RE: 8500 Glendale Ave. NE
Grading and Drainage Plan
Engineer's Stamp Date: 05/28/19
Hydrology File: B20D067

Based upon the information provided in your resubmittal received 06/25/2019, the Grading and Drainage Plan is approved for Building Permit, Grading Permit, and for action by the DRB on Site Plan for Building Permit.

RE File: B20D067, 8500 Glendale Ave. NE

Dear Ms. Brissette,
Attached is a revised plan set based on your comments of June 10th, 2019. I have addressed the comments as follows:

TITLE: **8500 Glendale Grading & Drainage Plan**

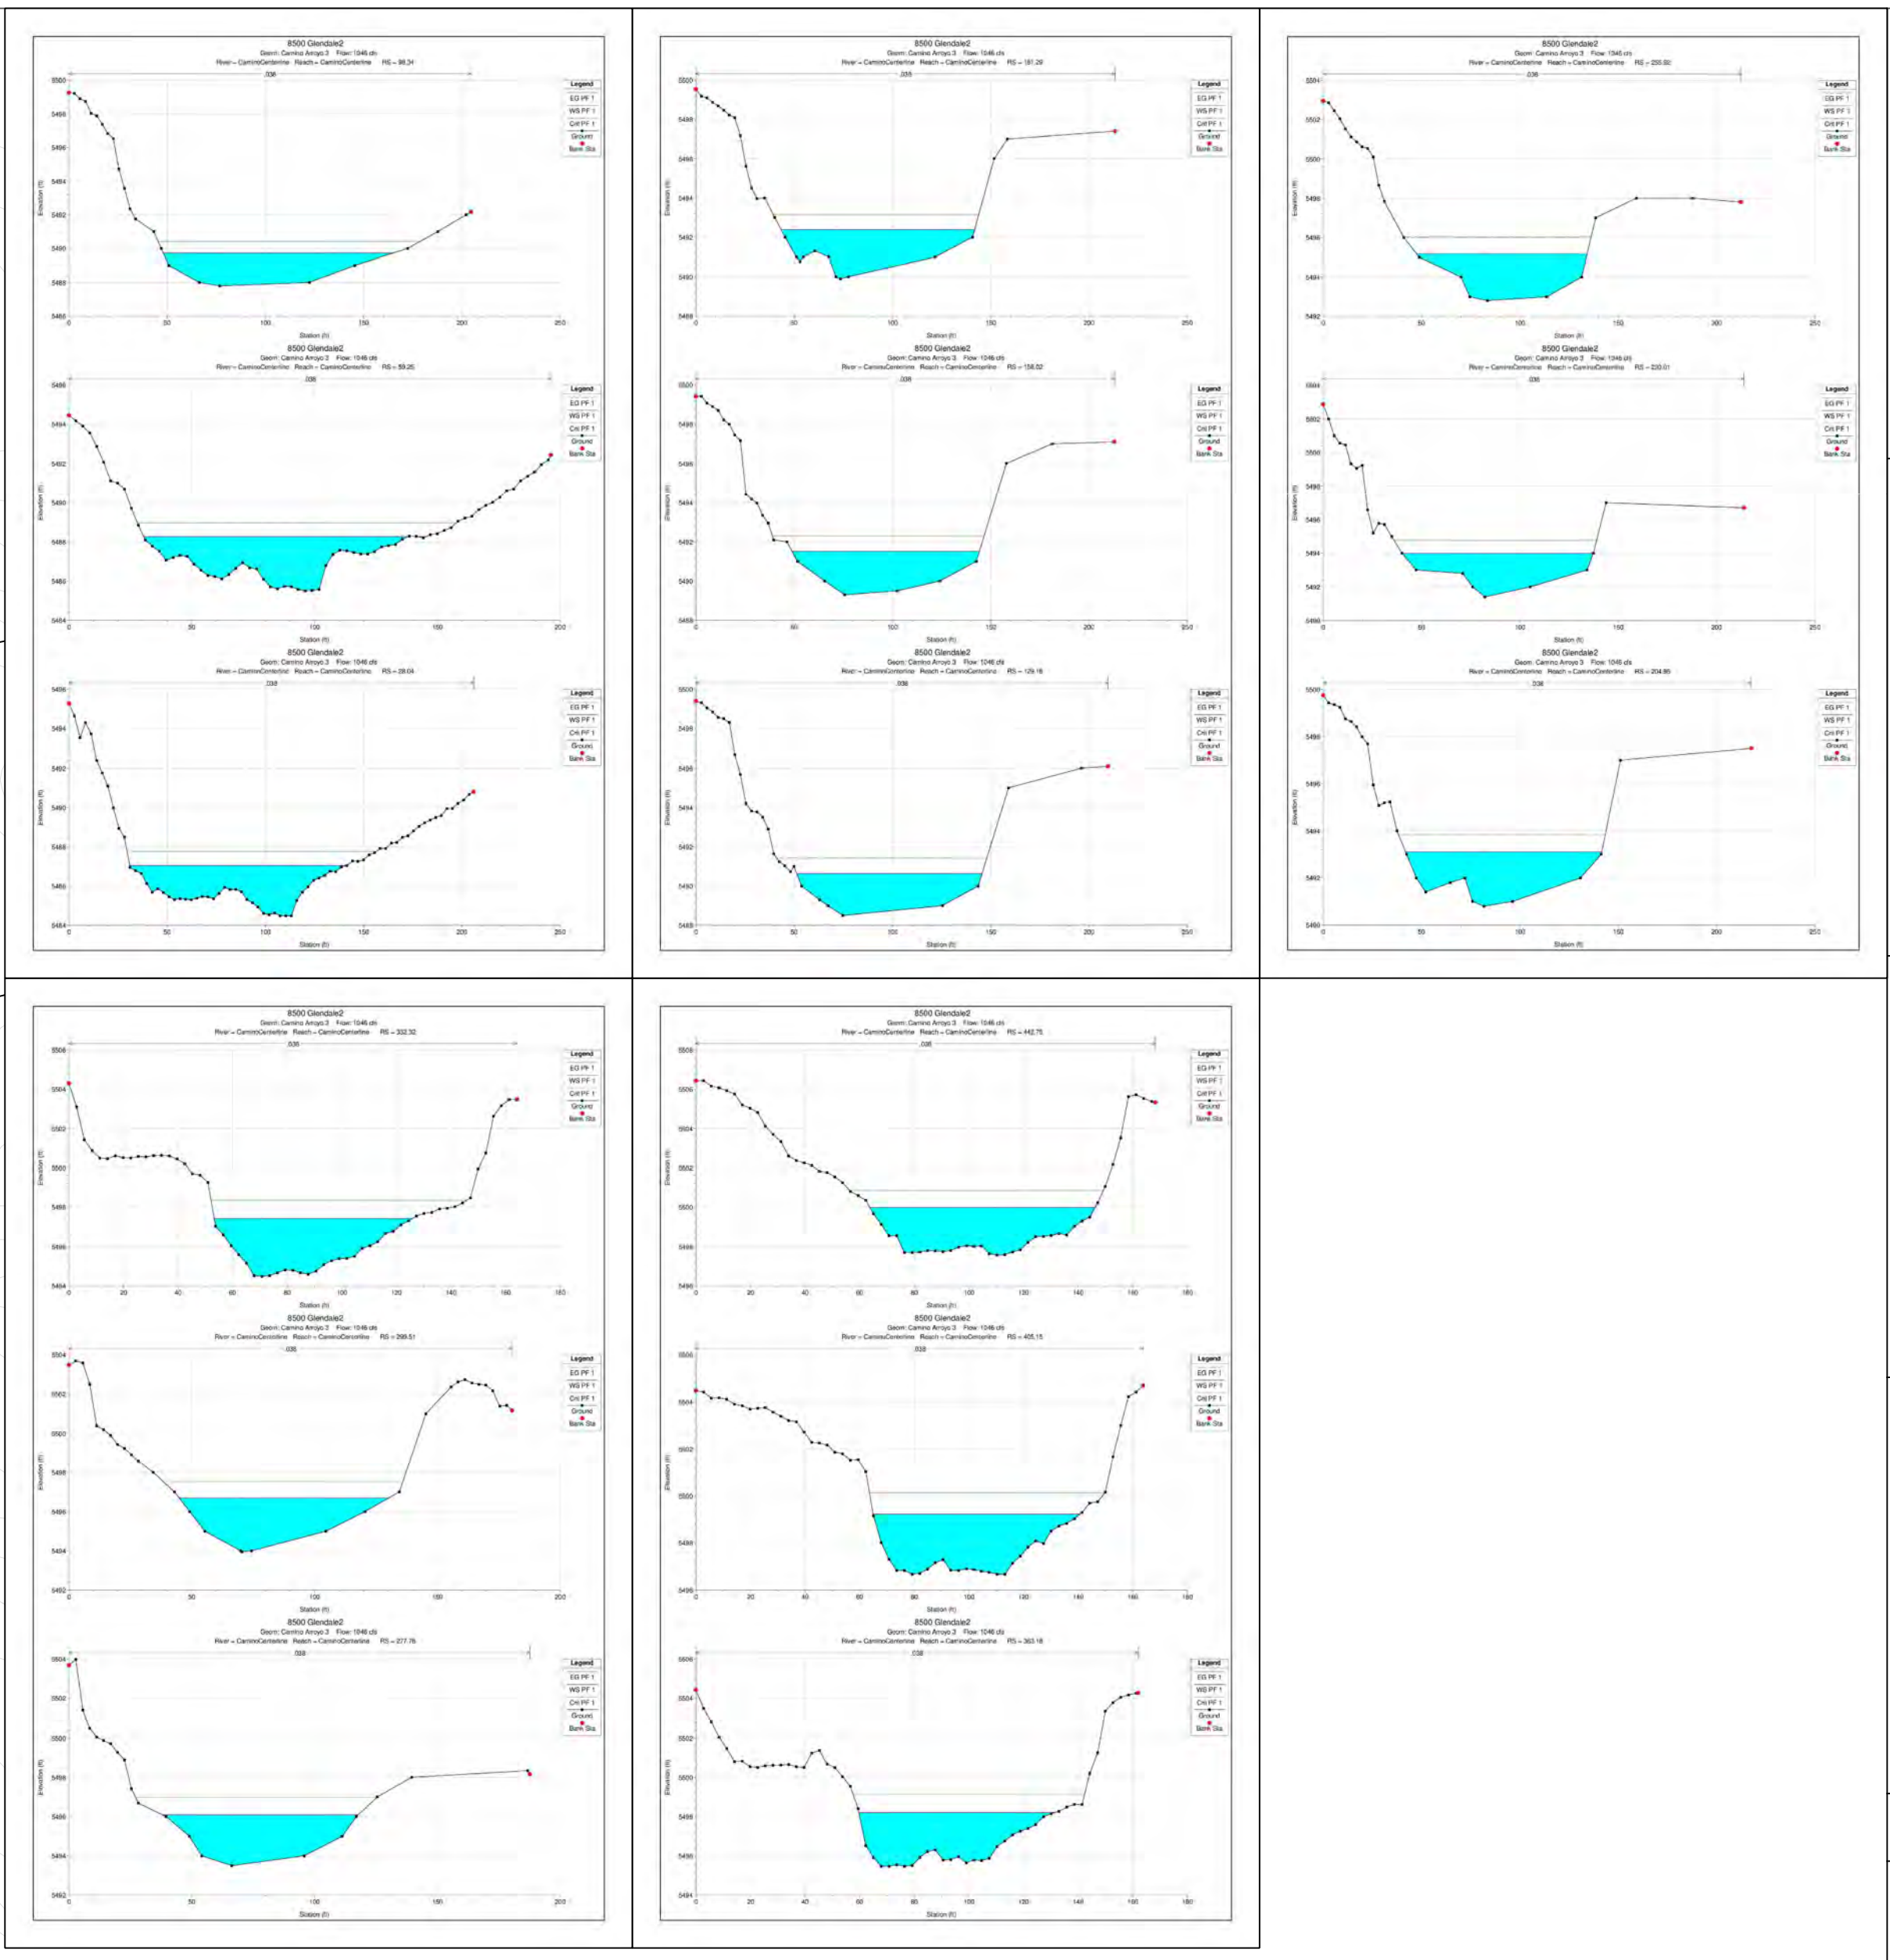
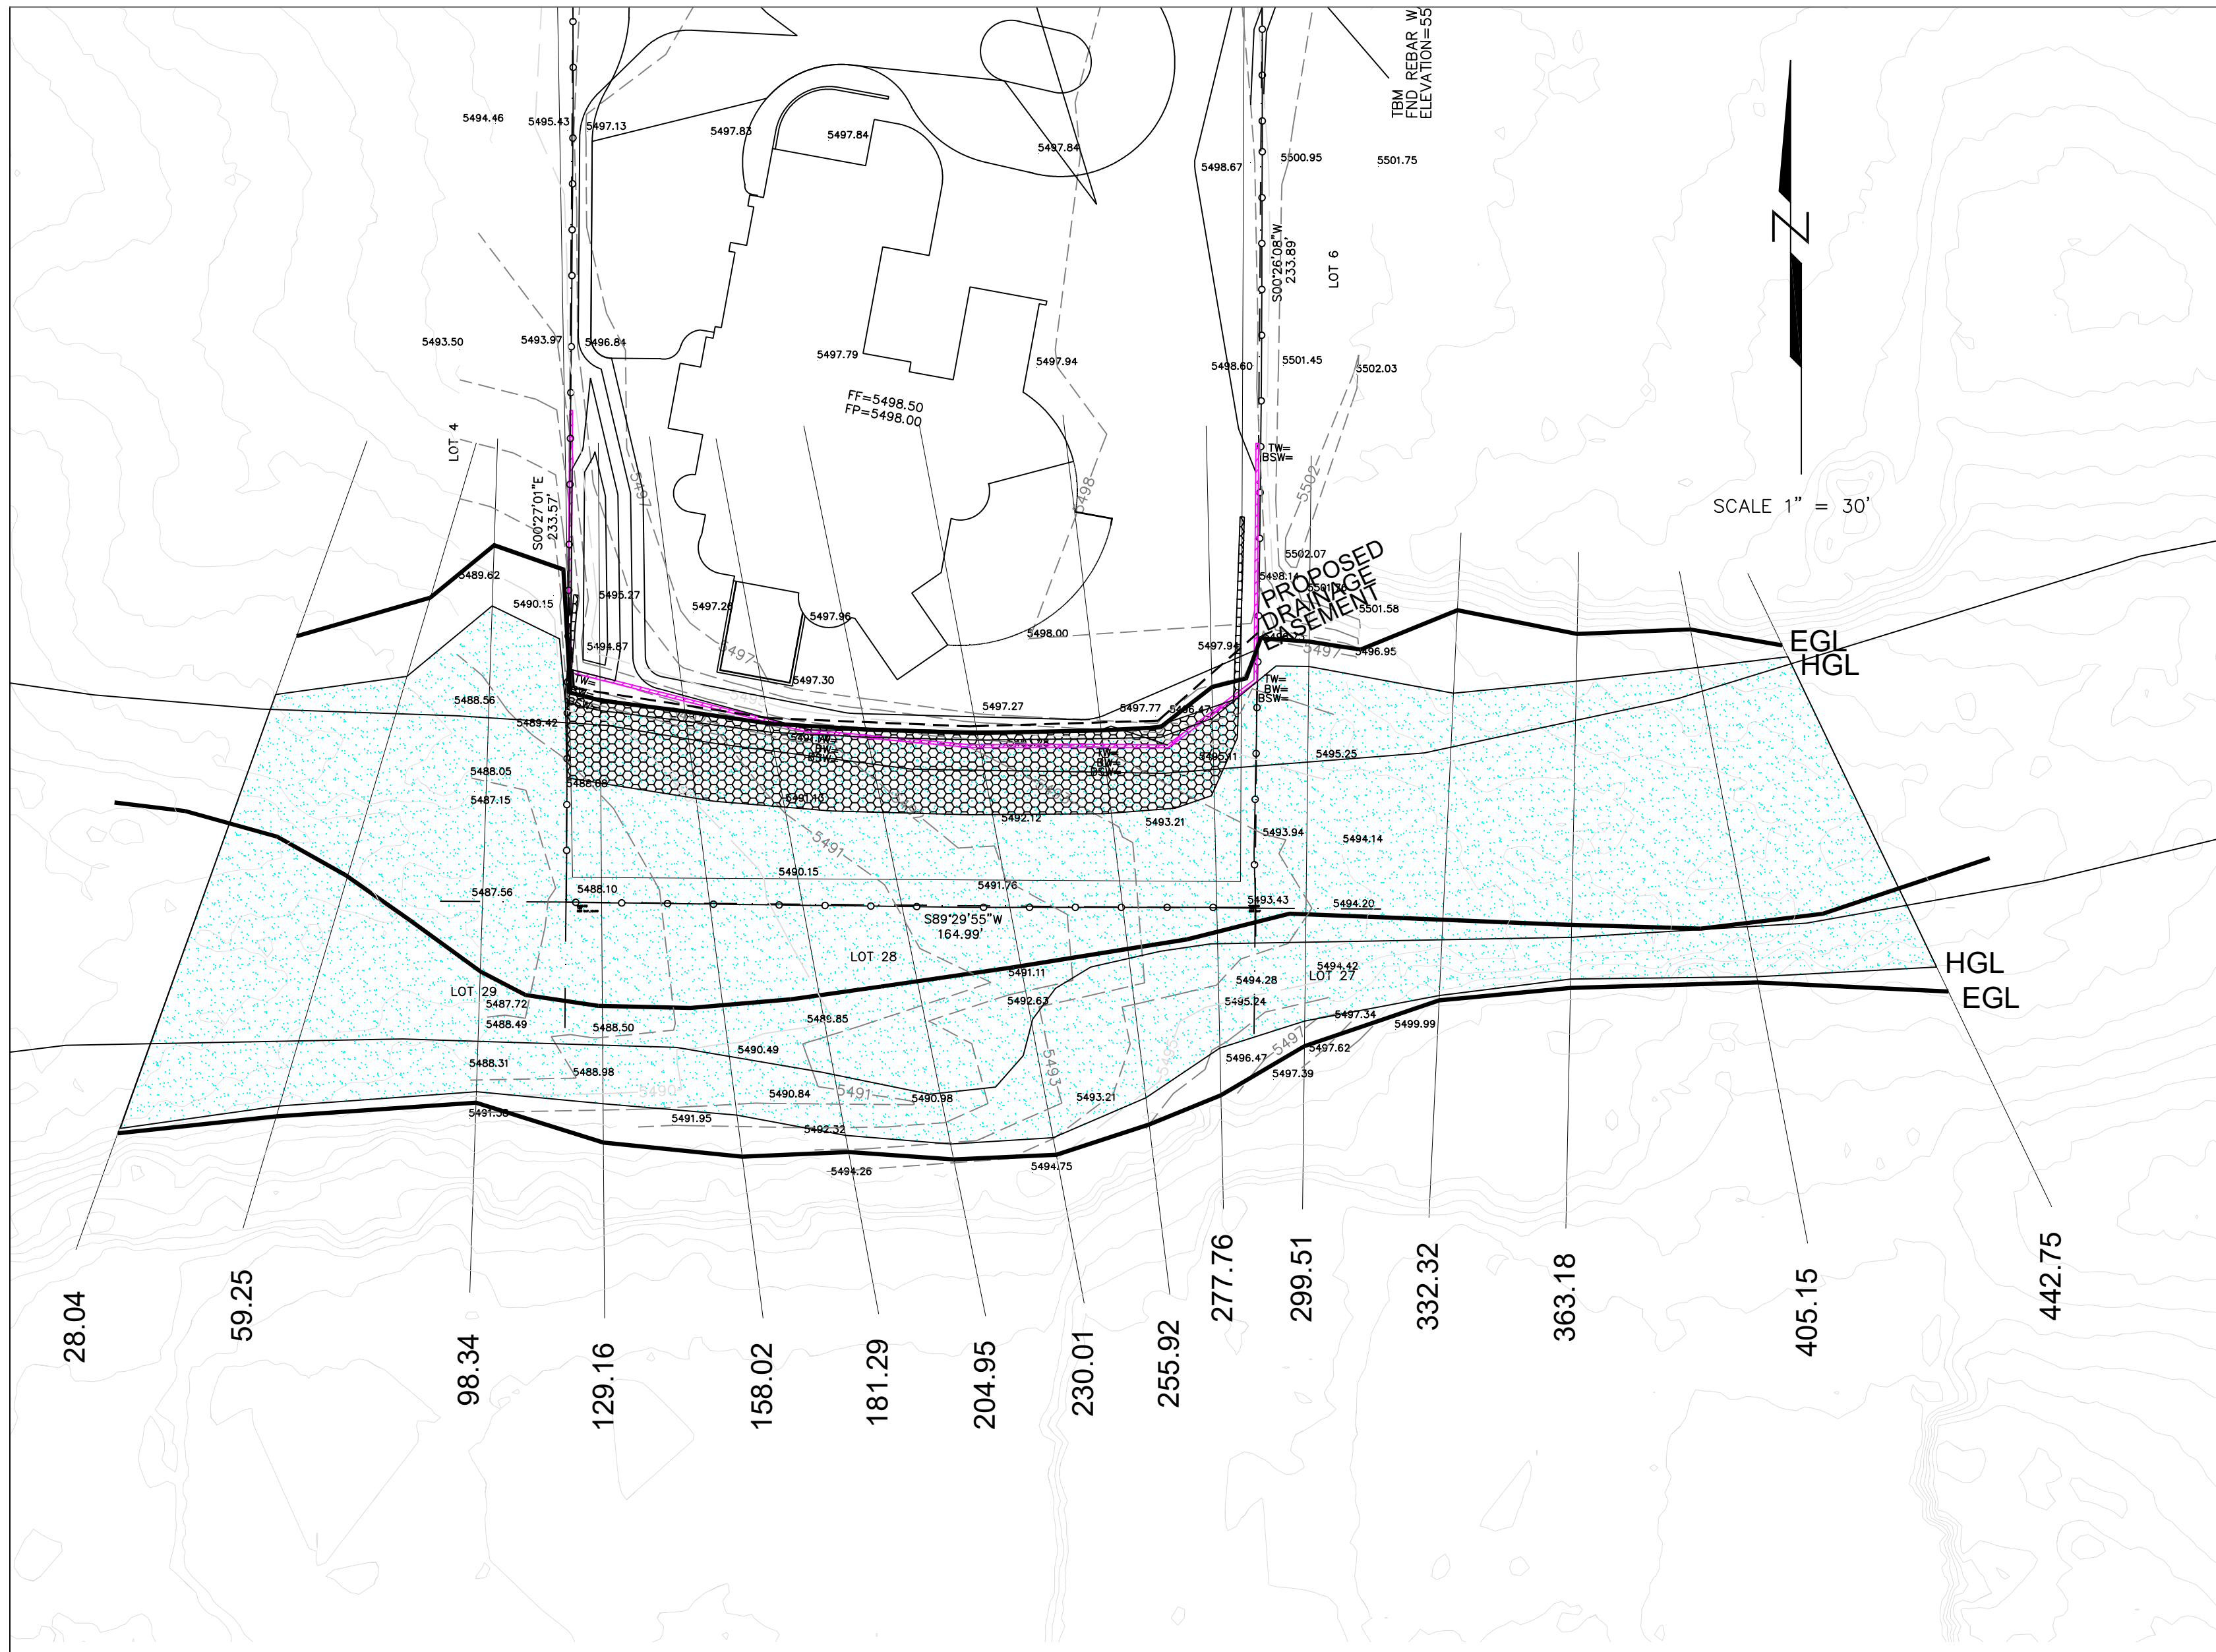
2. At the northwest and northeast corners of the property, there are proposed grading on the adjacent properties. Written approvals from both of the adjacent property owners are required prior to Building Permit approval. *Adjacent owners are being contacted.*
